Technical design note

Project name	Land North of Rectory Farm, Yatton		
Design note title	Response to IDB Comments dated 15th May 2023		
Document reference	23257-HYD-XX-XX-TN-D-0002		
Author	Richard Hughes		
Revision	P02		
Date	7 July 2023	Approved	✓

Point B - Cross Section Locations
Cross Sections

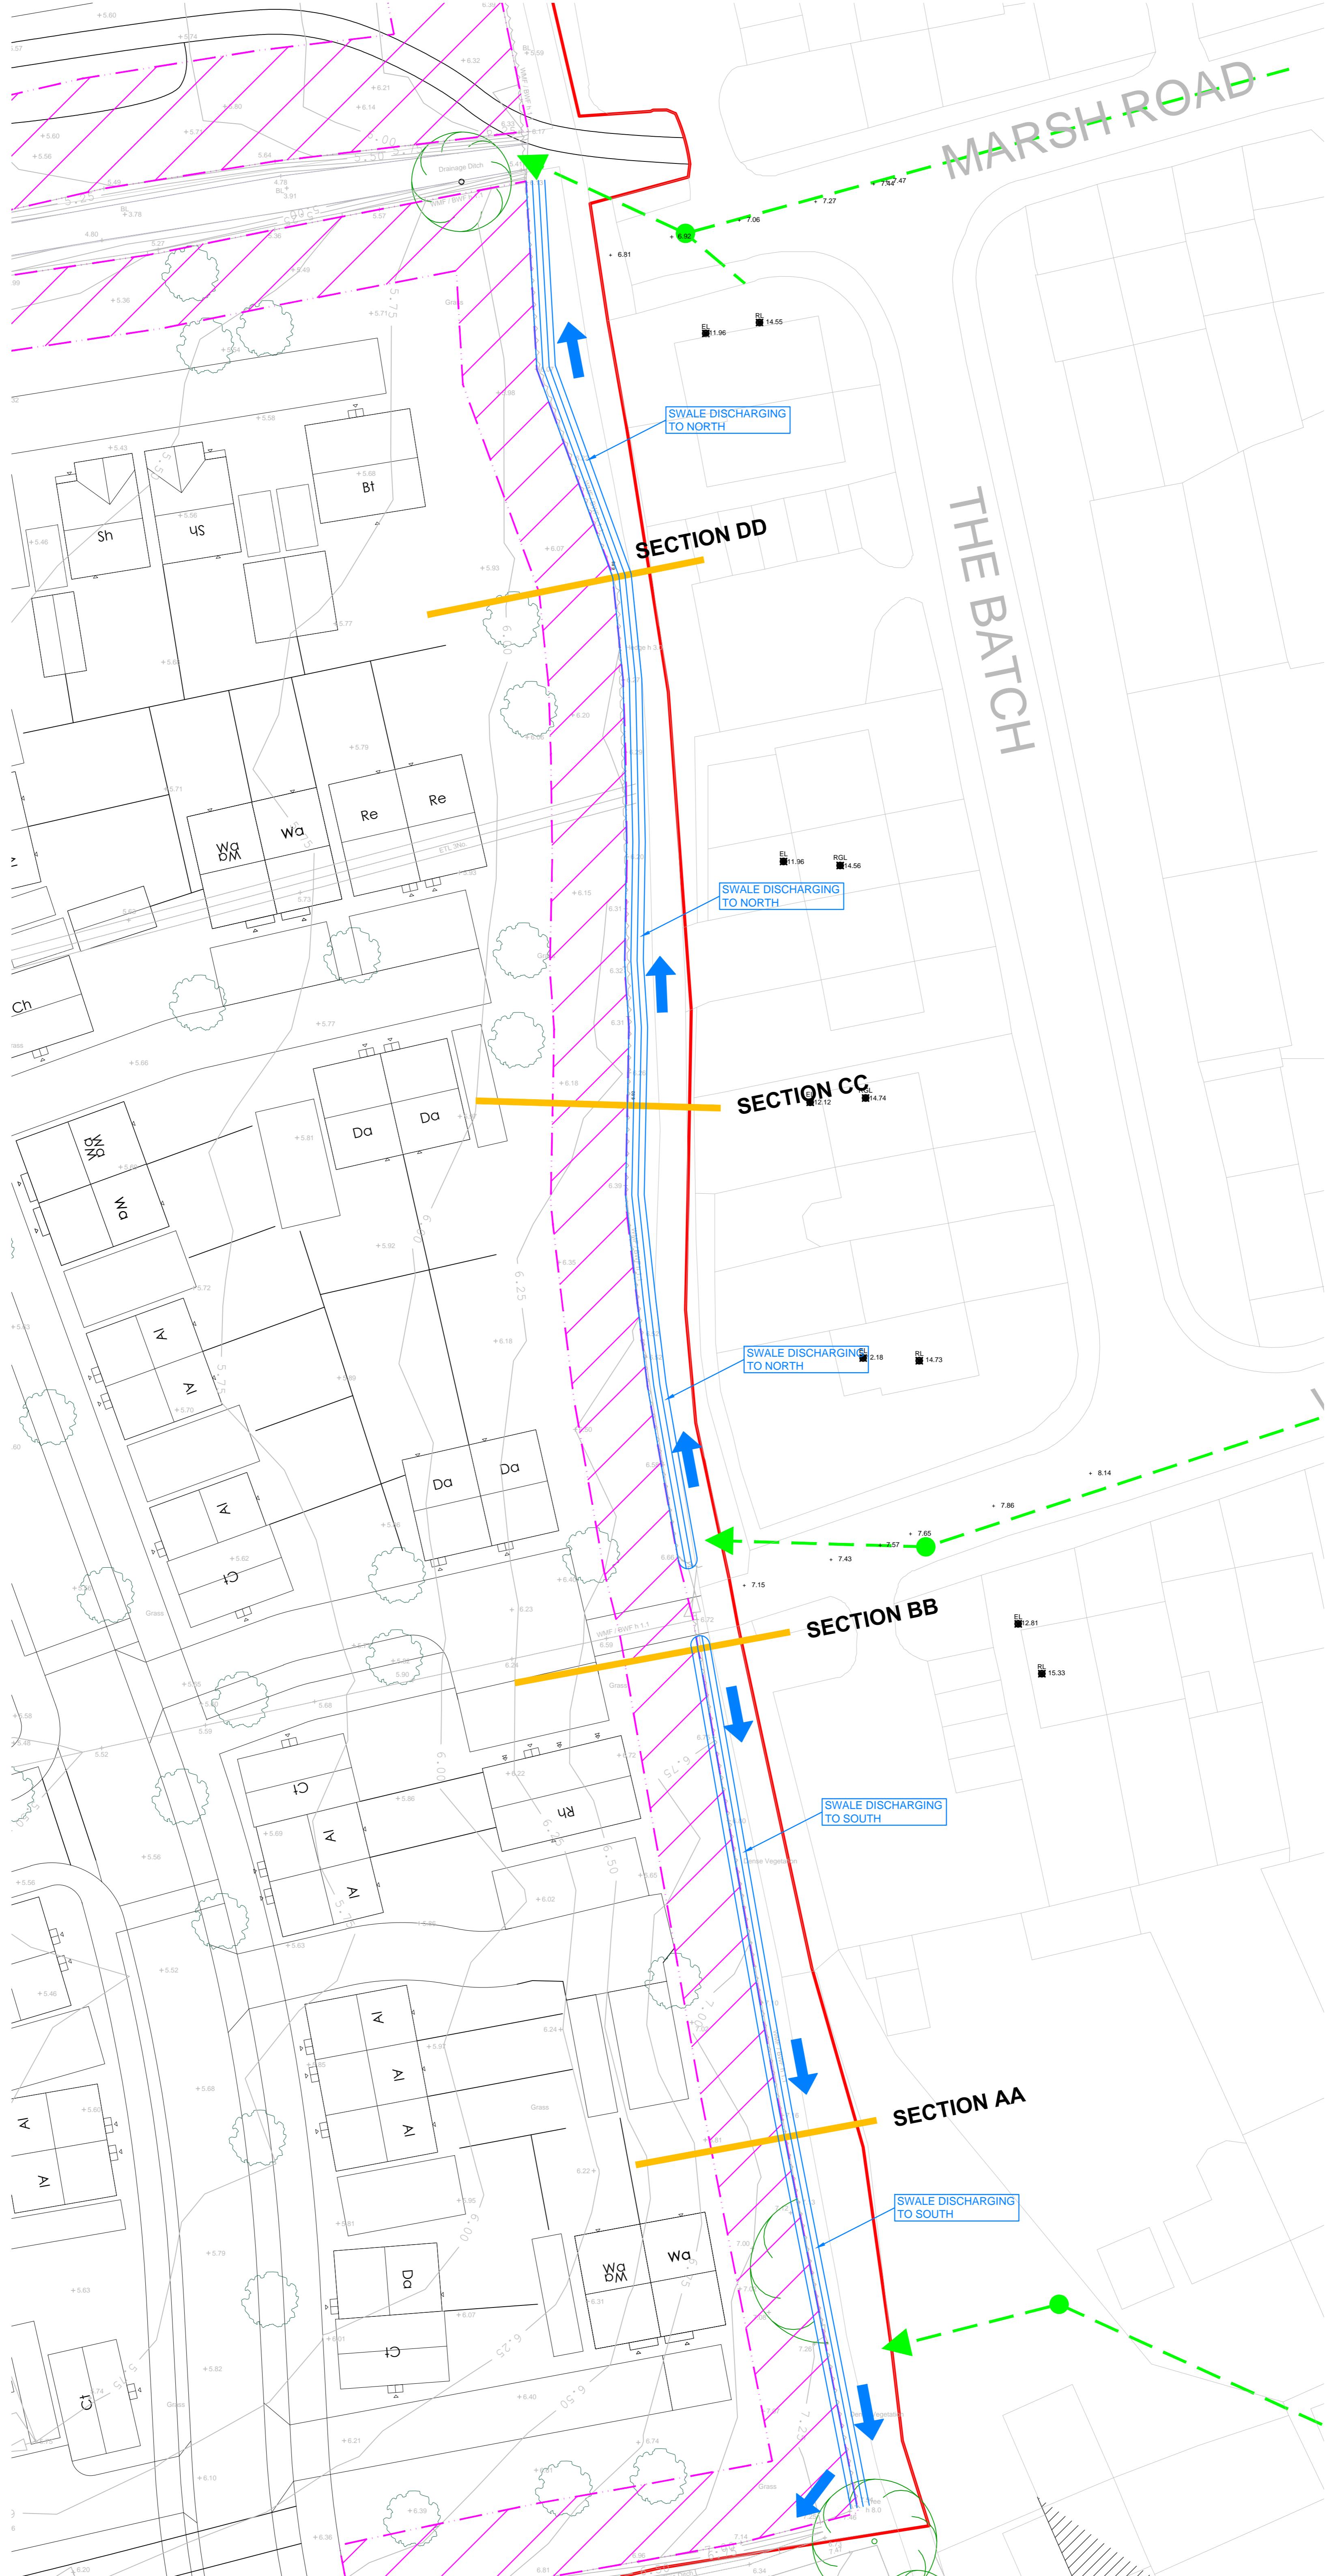
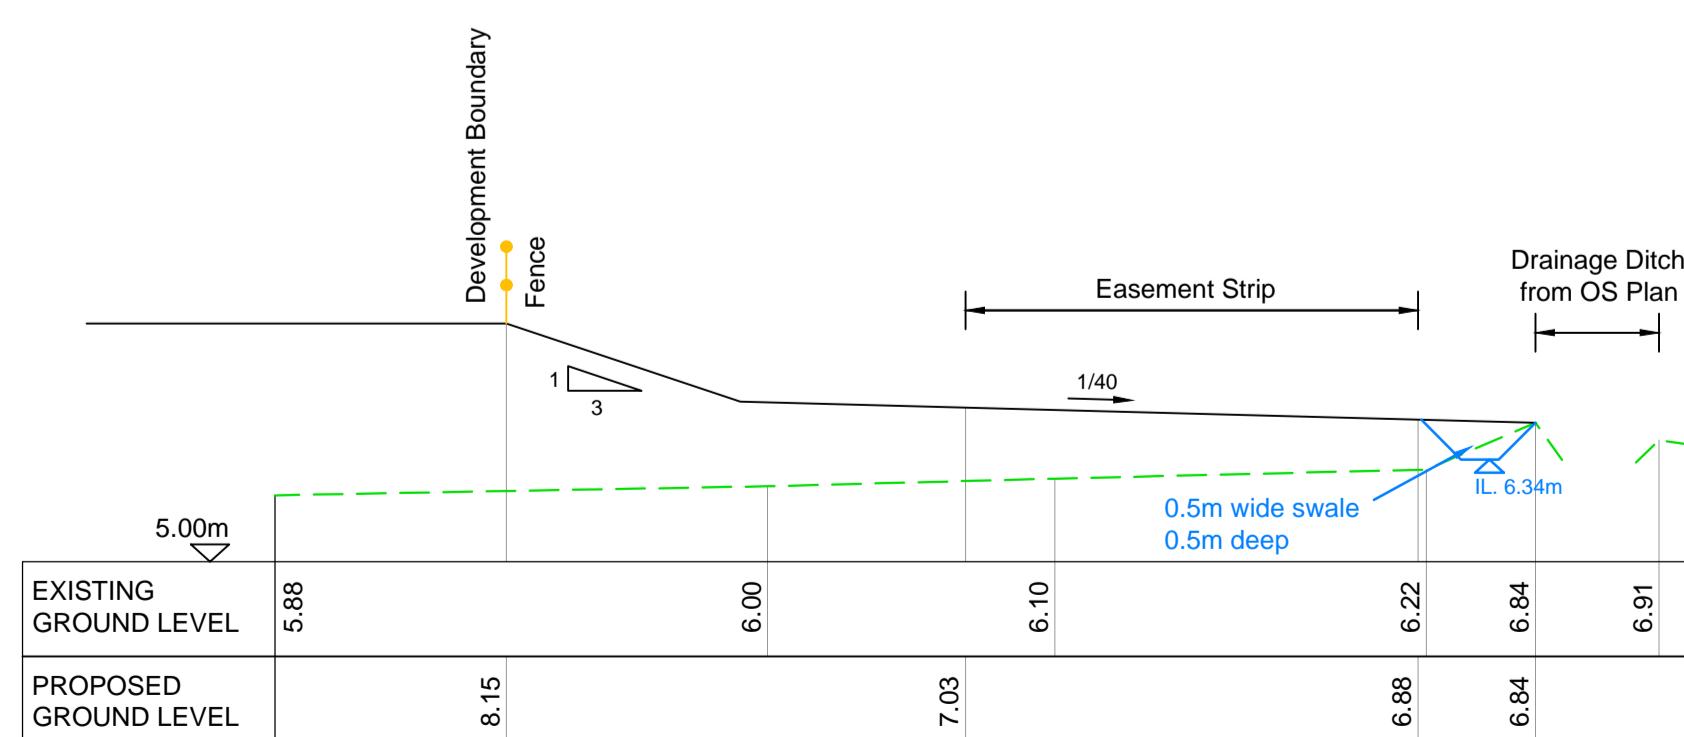
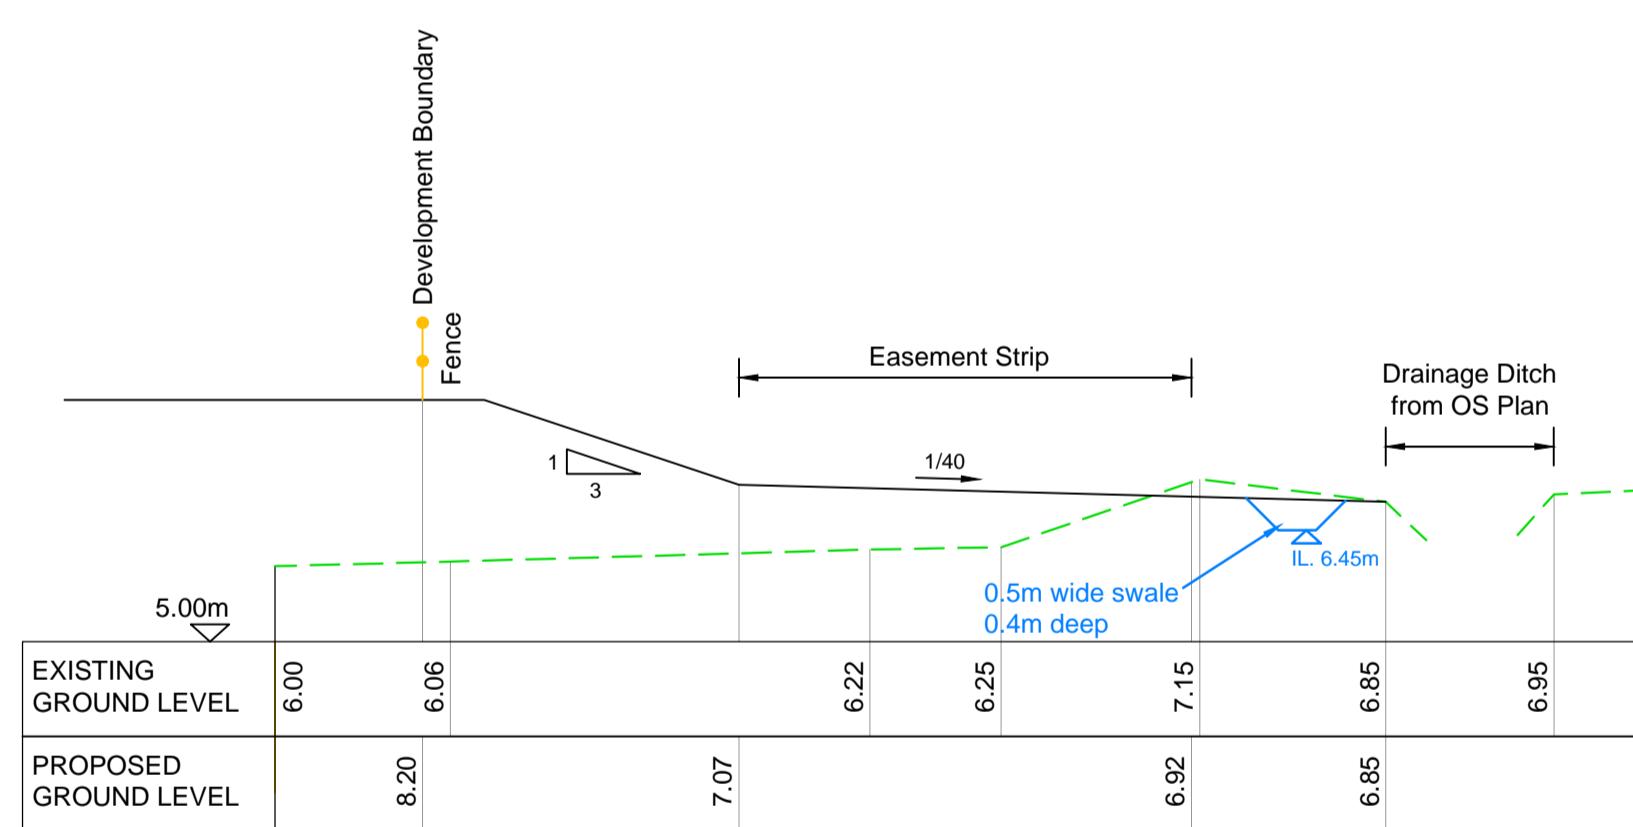
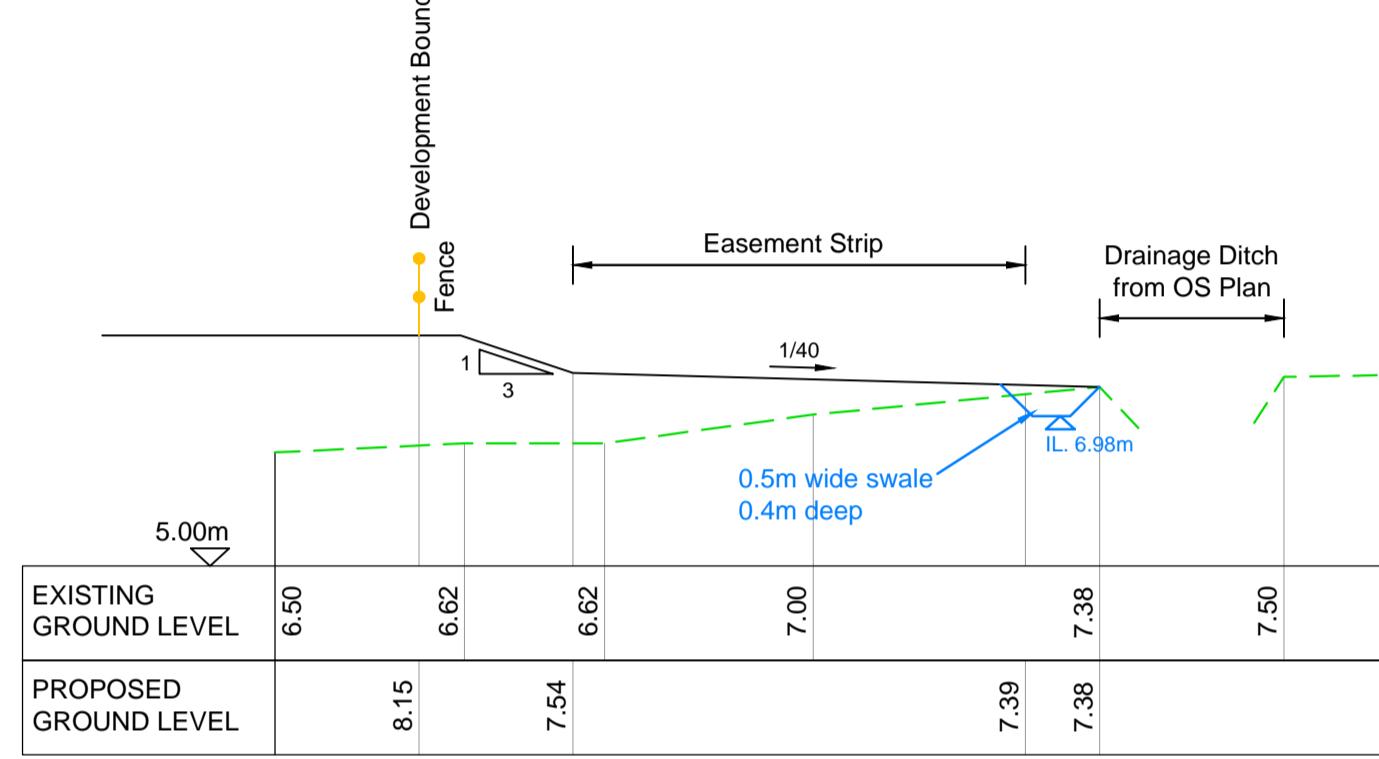
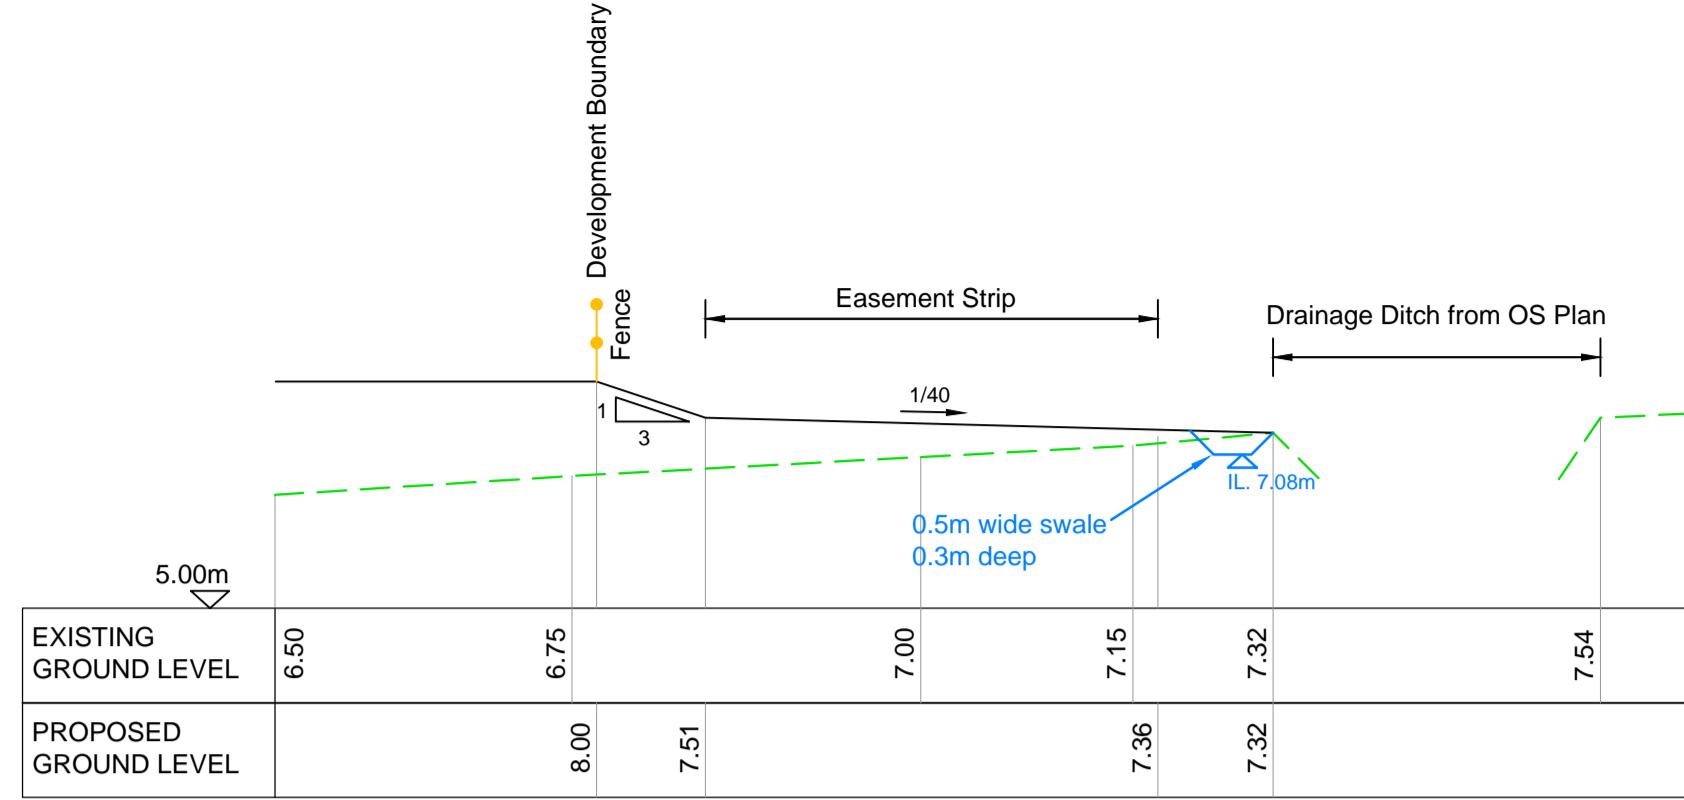
The IDB pipeline and existing ditch along the western boundary of the existing development captures and routes away town surface water which previously caused parts of the eastern edge of the proposal fields to remain permanently wet. A section of the boundary has no positive drainage at present and to ensure that the ground raising does not obstruct the ground water further land drainage measures may be required. A plan and sections through the Eastern boundary showing proposed ground levels, boundary treatment and drainage details is required to assess this.

A set of cross-sections have been prepared along the boundary to the north and south of West Road and are attached in Appendix D of this Technical Note. Where a ditch does exist, this will lie outside of the development boundary and will be unaffected and any runoff can discharge to this ditch. Where there is no positive drainage, a shallow swale can be created to direct any surface water to existing ditches both north and south.

Typical Rhyne Crossing and Maintenance Strip Cross Section

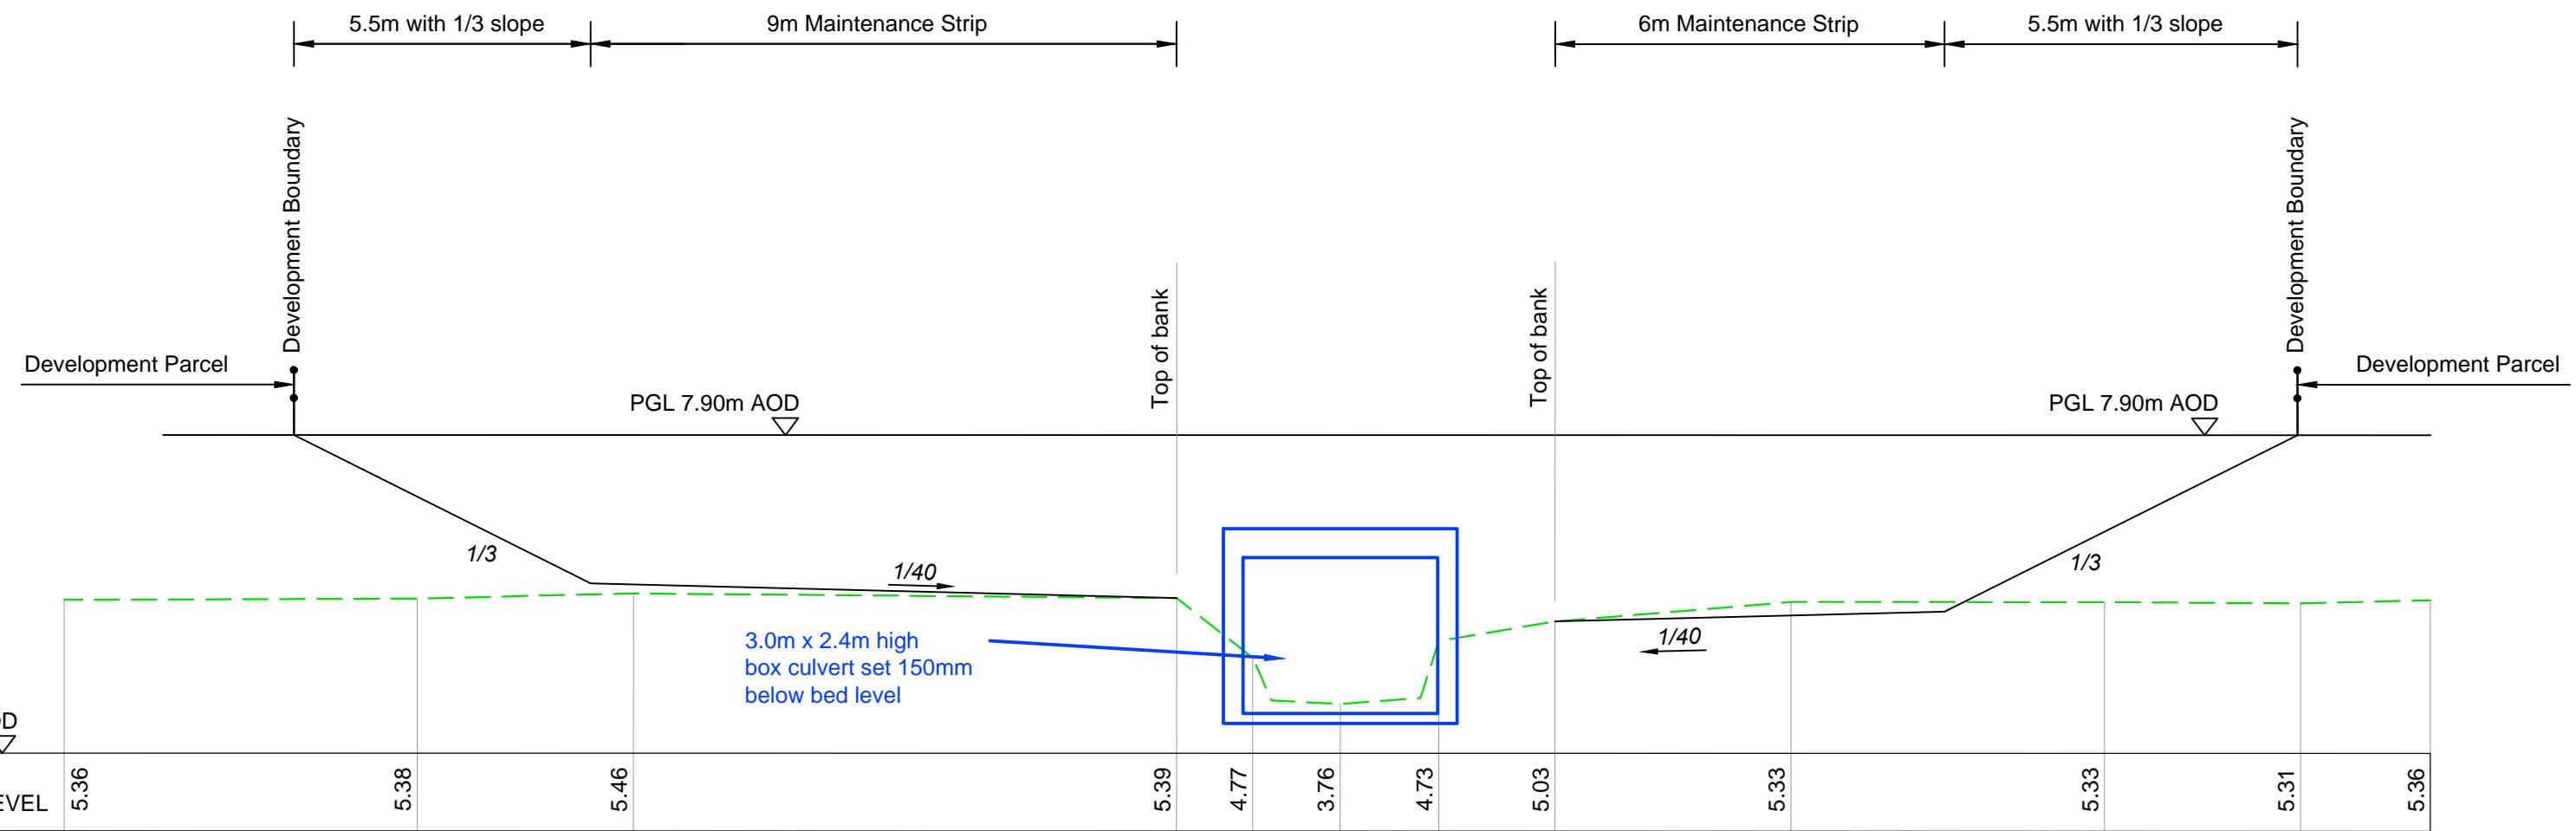
BC This length is IDB adopted and maintained. A sketch cross section of the proposed arrangement has been provided but the width between the tops of the slopes (approx 32m?) does not appear to be replicated on the plans of watercourse

The distance between the watercourses and the top of the slopes appears to be inadequate to accommodate the 6m / 9m accesses strips and the 1 in 3 slopes. Cross sections needed.

New culverts – IL should be 150mm below bed level to encourage habitat continuity.

The tops of the 1 in 3 slopes at the rear of the easement widths are coincident with the edge of the development proposals – see attached sketch in Appendix E. The width across the top of the slopes will vary depending on the difference in ground level and therefore is a typical arrangement.

A typical cross-section is attached in Appendix E. Additional cross-sections will be prepared at the Reserved Matters stage when a more detailed planning layout will be available.

The typical cross-section in Appendix E has been amended to show this requirement.
